**SUBJECT: SAFETY RECALL OF MCI COACHES WITH ELECTRONIC STABILITY CONTROL**

Ref.: **NHTSA # (MCI) 11V-524**  
**NHTSA # (Meritor WABCO) 11E-039**  
**TRANSPORT CANADA #TC 2011-377**  
**MCI Service Bulletin 371**

# Service Bulletin No. 371

<b>MODEL</b> D / E / J Series Coaches	<b>TYPE</b> Field Change Program	<b>SECTION/GROUP</b> 4--Brakes & Air System	<b>DATE</b> Dec. 17, 2011
<b>SUBJECT</b> ELECTRONIC STABILITY CONTROL ( ESC ) MODULE			
<b>CONDITIONS</b>

**Figure 1.**

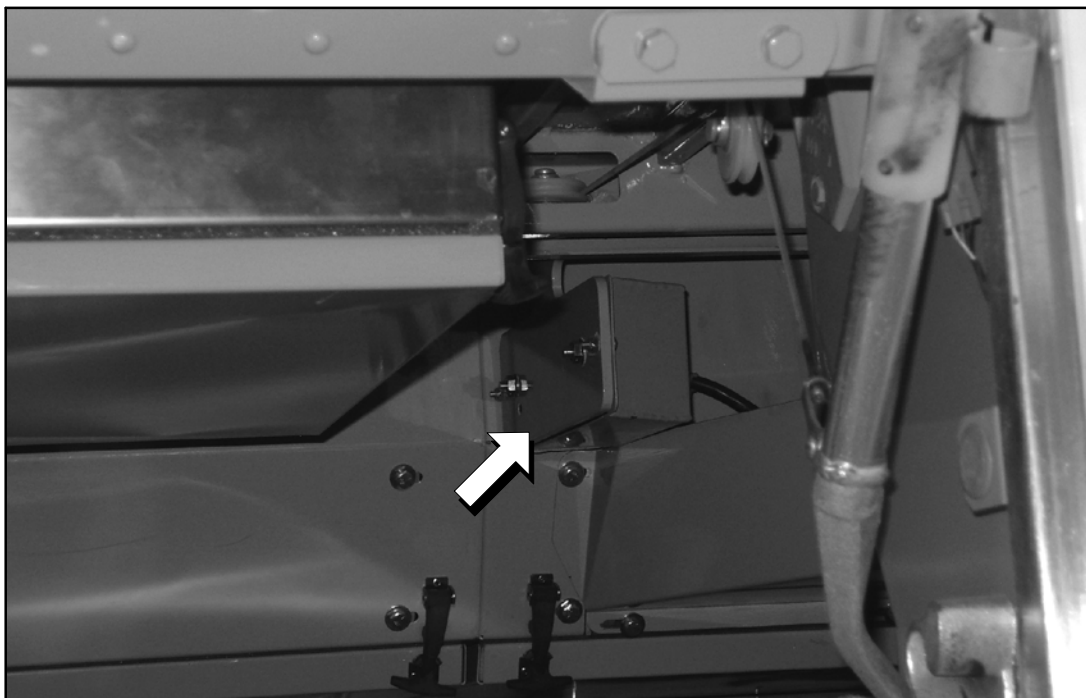
3. Open the #3 baggage bay compartment curbside and roadside doors. Insert the positive lock pin to secure the door in the open position.
4. Locate the ESC module on the rear section of the roadside baggage bay compartment ( refer to Figure 1).
5. Remove and retain the cover mounting hardware ( refer to Figure 1). Place the cover and hardware aside to be re-installed at a later step in this procedure.

7. Remove and retain the ESC module mounting hardware. Remove and retain the existing ESC module to be returned to MCI.
8. Using the mounting hardware removed in Step 7, install the new ESC module, p/n 04-31-1110.
9. Re-connect the harness disconnected in Step 6.
10. Using the mounting hardware removed in Step 4, re-install the ESC module cover.
11. Close the baggage bay compartment doors.
12. Proceed with Step 1 to Step 6 on Pages 2 to 4 of the attached Meritor–WABCO Technical Bulletin TP– 1205 / Procedures for ECUs with Software Revision E435, E436, E440 or E441, following all warnings and cautions therein.

**Figure 3. Reference photo.**

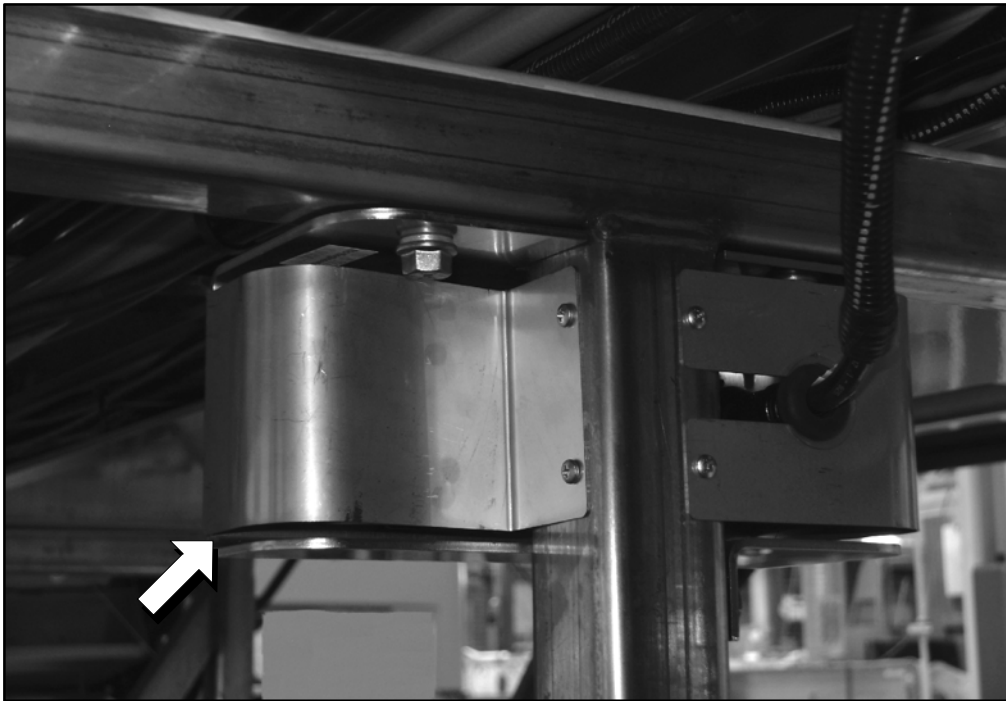
13. Open the #3 baggage bay compartment curbside and roadside doors.
14. Locate the ESC module on the center post of the baggage bay compartment ( refer to Figure 3 ).

17. Remove and retain the ESC module mounting hardware. Remove and retain the existing ESC module to be returned to MCI.
18. Using the mounting hardware removed in Step 17. , install the new ESC module, p/n 04-31-1110.
19. Re-connect the harness disconnected in Step 16.
20. Using the mounting hardware removed in Step 15. , re-install the ESC module cover.
21. Close the baggage bay compartment doors.
22. Proceed with Step 1 to Step 6 on Pages 2 to 4 of the attached Meritor-WABCO Technical Bulletin TP-1205 / Procedures for ECUs with Software Revision E435, E436, E440 or E441, following all warnings and cautions therein.

**Figure 6**

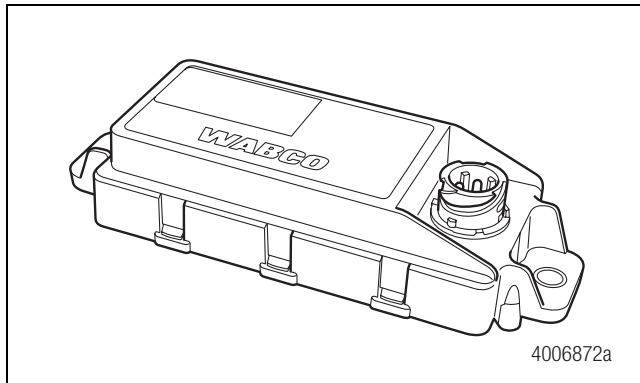
1. Park the vehicle on a level surface with the steering wheel centered and the front wheels positioned straight ahead.
2. Turn the ignition switch to the OFF position and apply the parking brake.
3. Block the wheels to prevent the vehicle from moving.
4. If necessary, raise the vehicle off the ground and place safety stands under the vehicle.
5. Disconnect the wiring harness connector from the ESC Module.
6. Remove the two mounting capscrews and nuts. Remove the ESC Module. Figure 6.

1. Install the new ESC5 module included in the kit with the two capscrews and nuts. Tighten the capscrews per the manufacturer's recommendation.

**Figure 10**

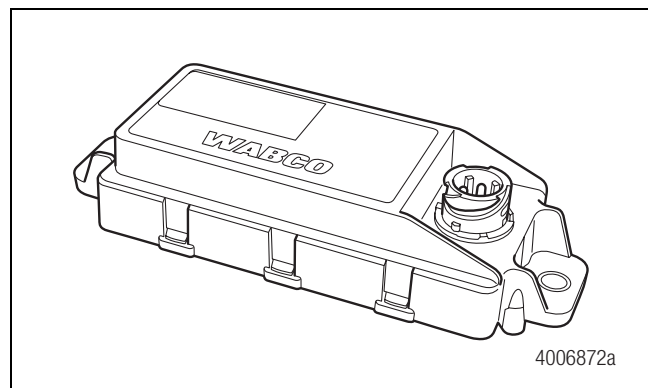
1. Park the vehicle on a level surface with the steering wheel centered and the front wheels positioned straight ahead.
2. Turn the ignition switch to the OFF position and apply the parking brake.
3. Block the wheels to prevent the vehicle from moving.
4. If necessary, raise the vehicle off the ground and place safety stands under the vehicle.
5. Disconnect the wiring harness connector from the ESC Module.
6. Remove the two mounting capscrews and nuts. Remove the ESC Module. Figure 10.

1. Install the new ESC5 module included in the kit with the two capscrews and nuts. Tighten the capscrews per the manufacturer's recommendation.
2. Connect the wiring harness connector to the ESC Module. Hand-tighten only.
3. Remove the stands and blocks.
